**TECHNICAL SERVICE BULLETIN**  
**SB-63 2022 Allegro Bay 38 AB Water Tanks Heating Pad**

## Technical Service Bulletin Inspection & Repair Instructions

**Tiffin Motorhomes Technical Service Bulletin # SB-63**

**Models Involved:** 2022 Allegro Bay 38AB

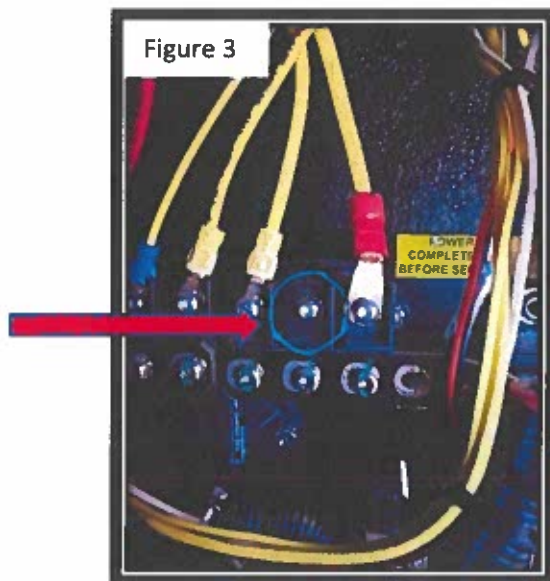
3. The tank heat wire should be located on this breaker spot circled the Figure 3 below, if the wire is installed, no repair is needed. Please file a claim to Tiffin Motorhomes using the code above.

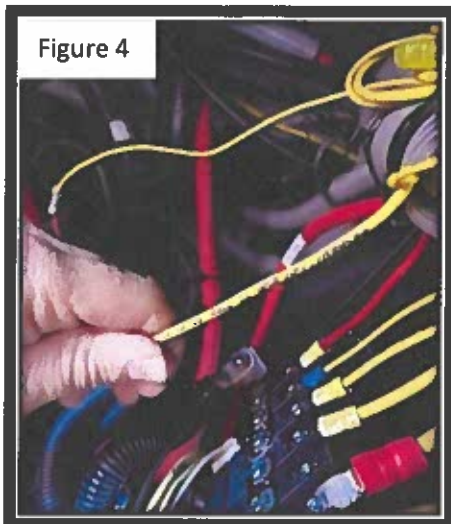
1. Locate the wire, "PWR TO TANK HEAT" will be printed on the wire, shown in Figure 4.

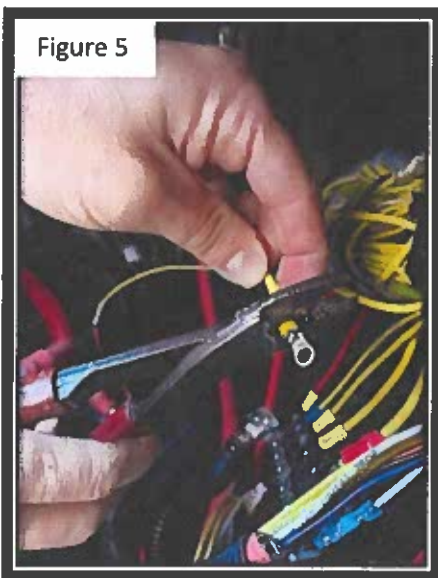
2. If the "PWR TO TANK HEAT" wire is long enough to connect to the DCD board, crimp ring terminal onto wire (Figure 5) and skip to step 5.

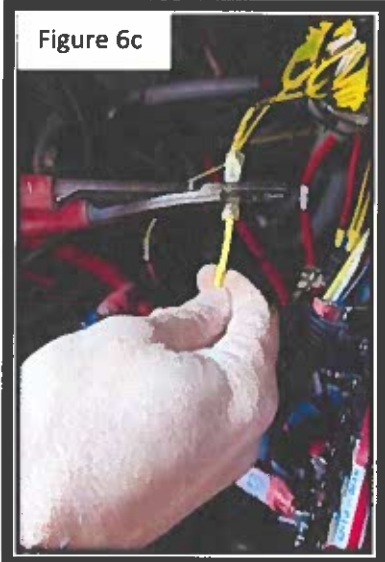
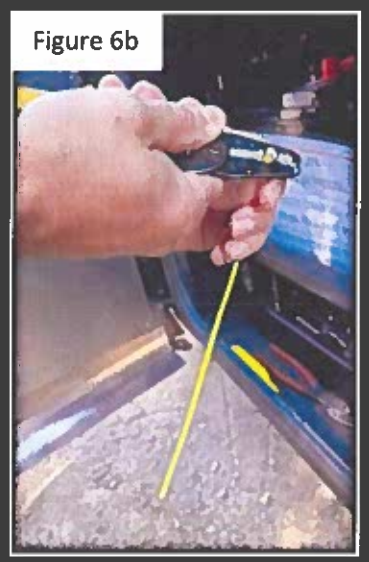
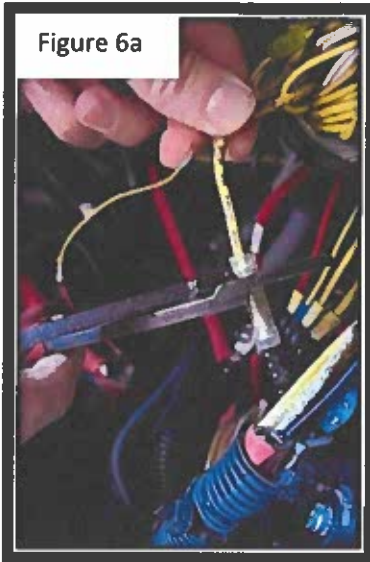
3. If the "PWR TO TANK HEAT" wire is not long enough to connect to the DCD board, strip wire and crimp on the butt connector. Strip the length of 12-gauge wire and crimp it on the other side of the butt connector that you put on the "PWR TO TANK HEAT" wire as shown in Figures 6a, 6b & 6c.

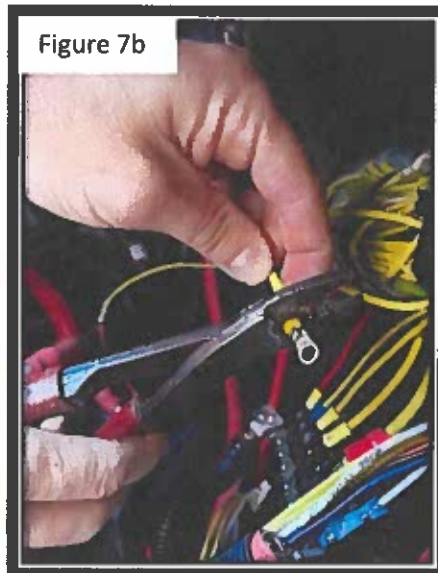
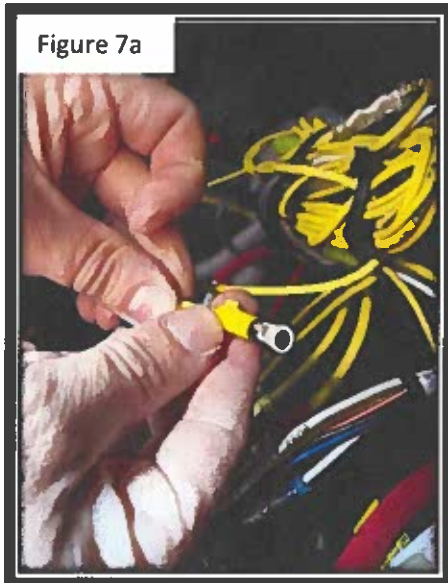
4. Cut 12-gauge wire to the appropriate length. Strip end of wire and place the ring terminal onto the wire then crimp as shown in Figure 7a & 7b.
